TDECQ changes (and consequent spec changes) for SMF and MMF clauses

802.3cd, Berlin, Germany, July 2017

Jonathan King, Finisar

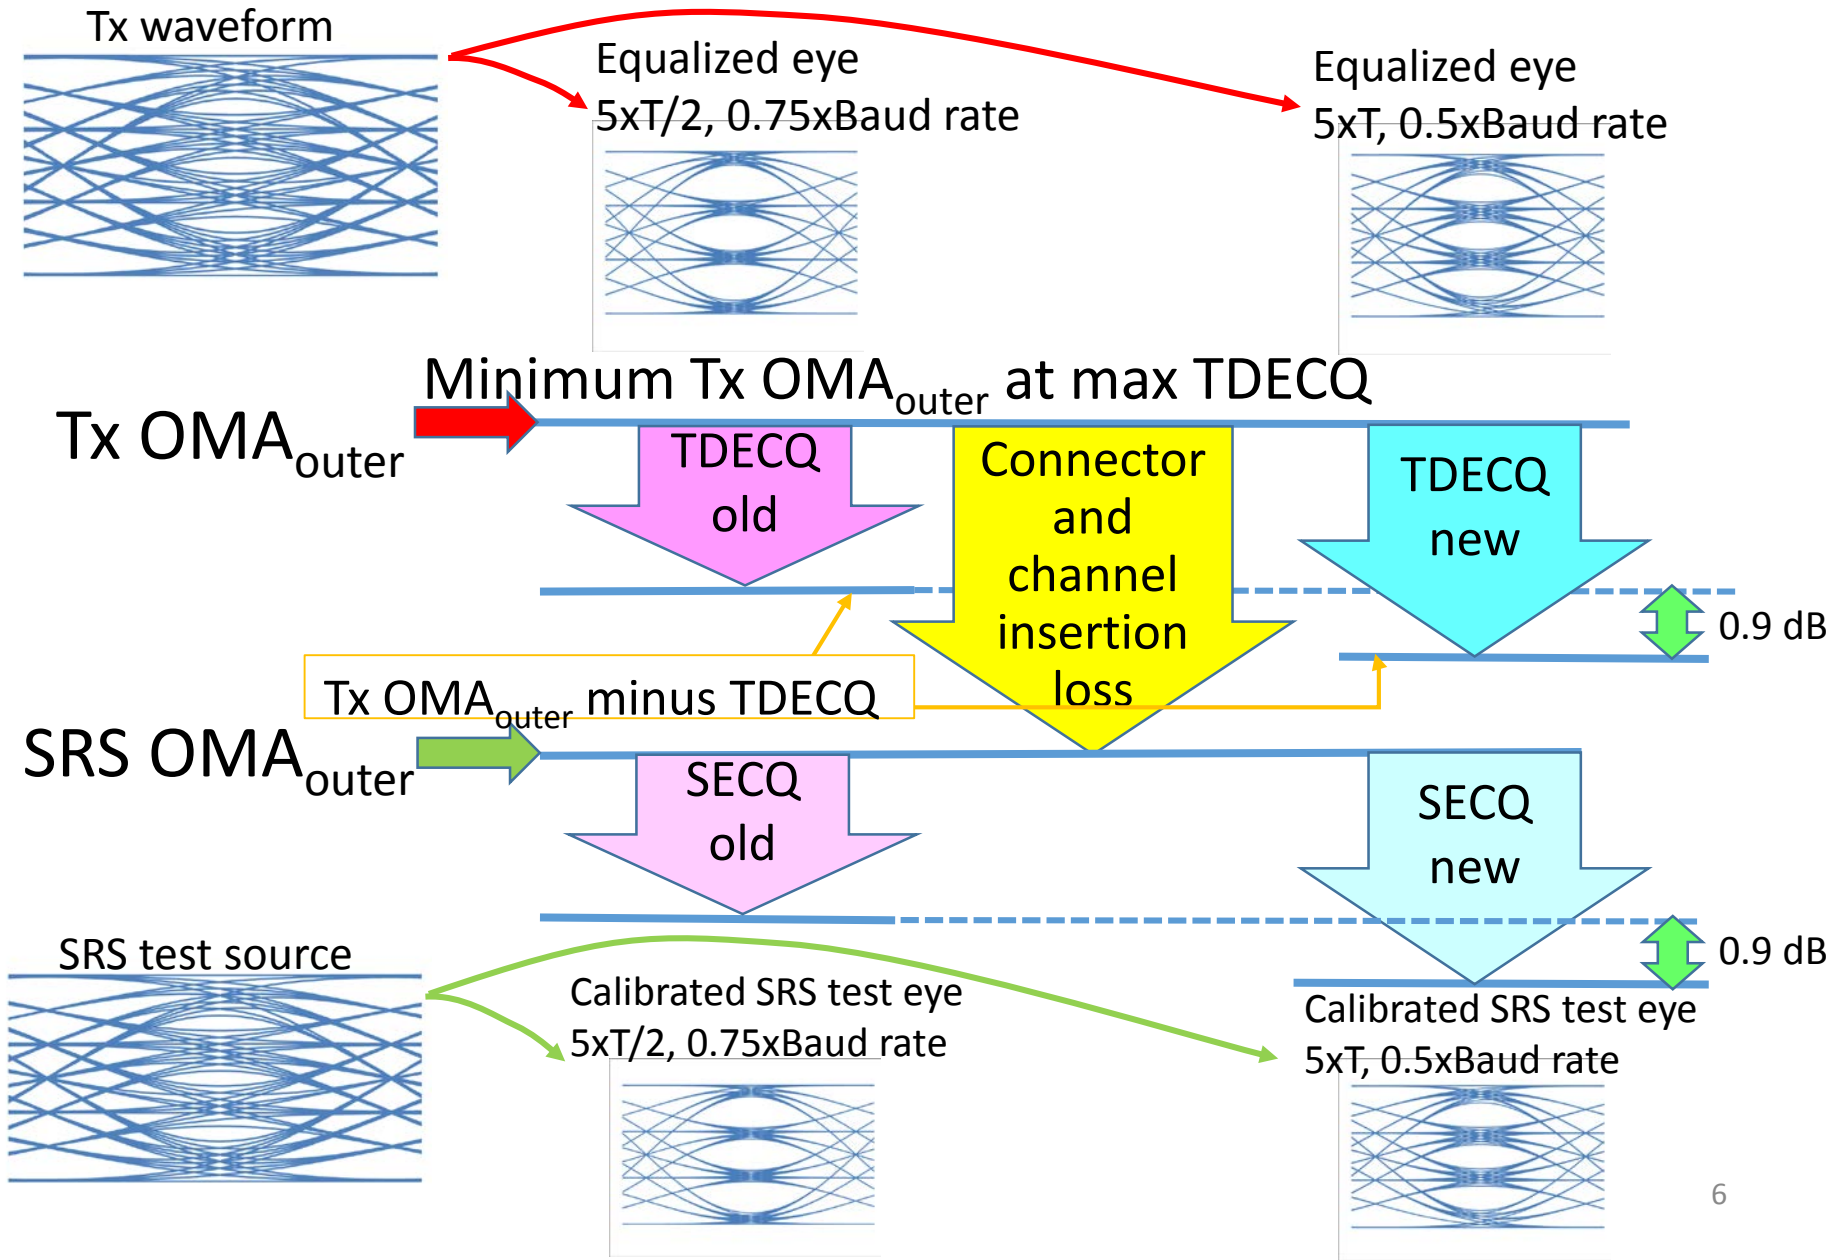
*Changing the TDECQ methodology doesn't change the transmitter characteristics, it's the same transmitter, but it's TDECQ is **measured** as larger for D3.2 TDECQ.*

The change to SECQ doesn't change the stress applied to the SRS test source, but it's SECQ is measured as larger for the D3.2 SECQ.

A specific receiver implementation isn't changed by the D3.2 SECQ - it's still the same receiver. If it could equalize and close the link with the SRS test source calibrated with D3.1 SECQ, it will still close link with D3.2 SECQ, without needing to change the input OMA to the receiver.

Specific changes for Clause 140, Table 140-8

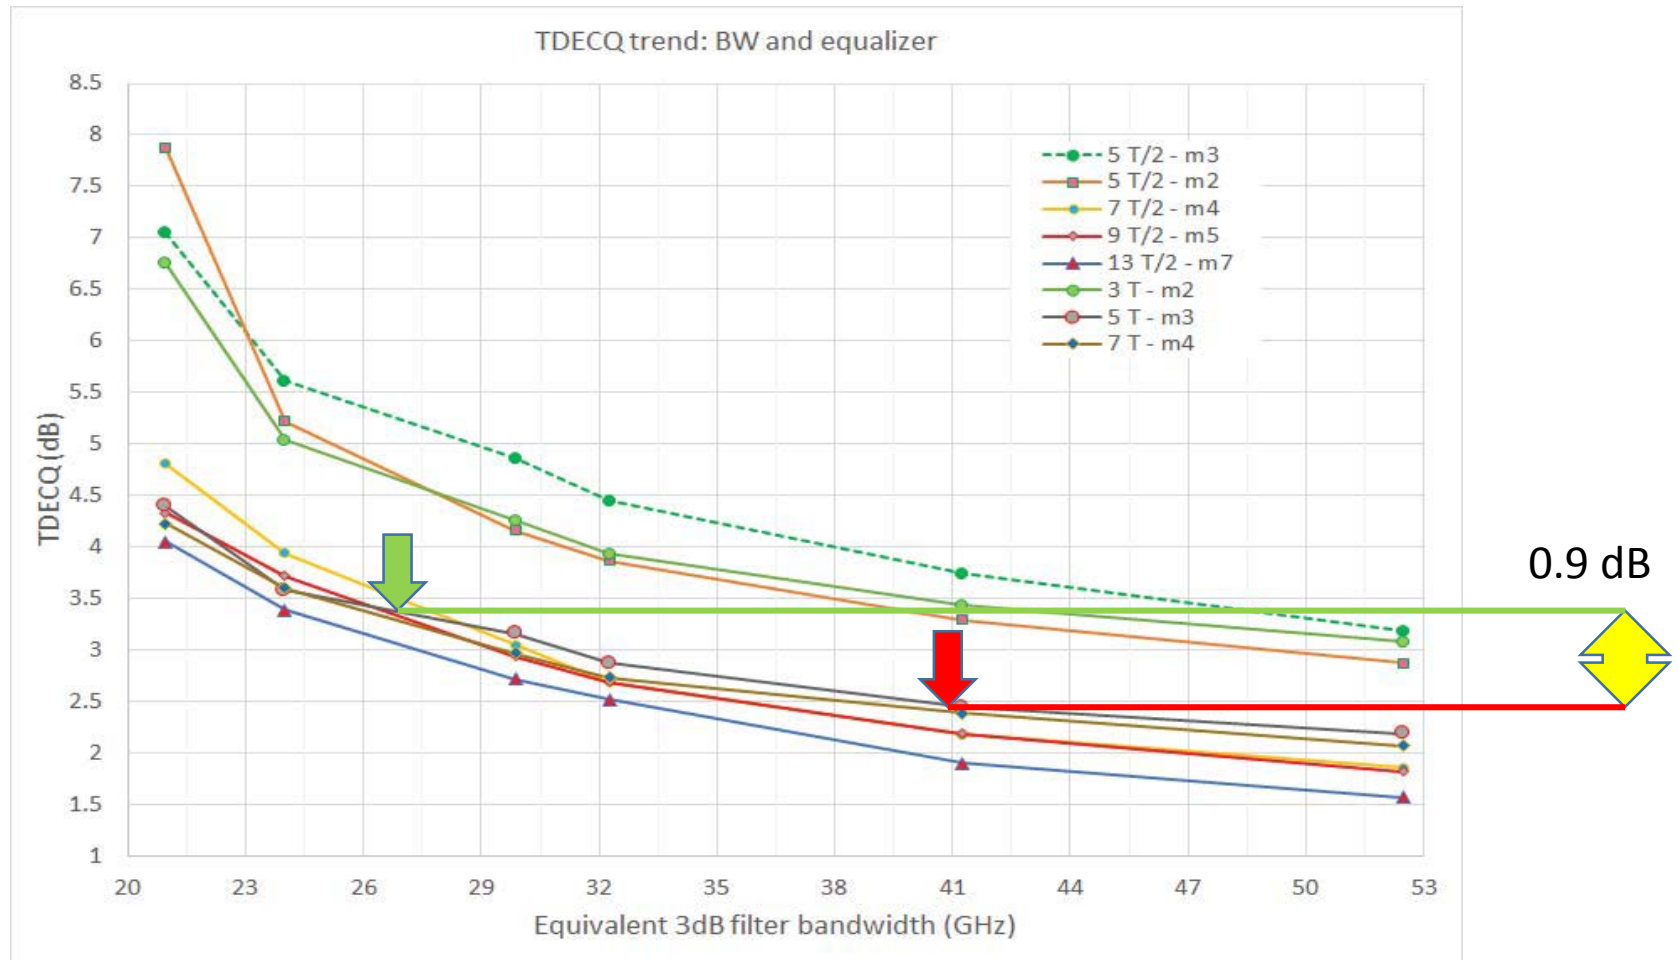
Parameter	Value	Unit
Power budget (for maximum TDECQ)	5.6 6.5	dB
Operating distance	500	m
Channel insertion loss ^a	See 140.9	dB
Maximum discrete reflectance	-35	dB
Allocation for penalties ^b (for maximum TDECQ)	5.6 6.5 minus max channel insertion loss per Table 140-12	dB
Additional insertion loss allowed	0	dB
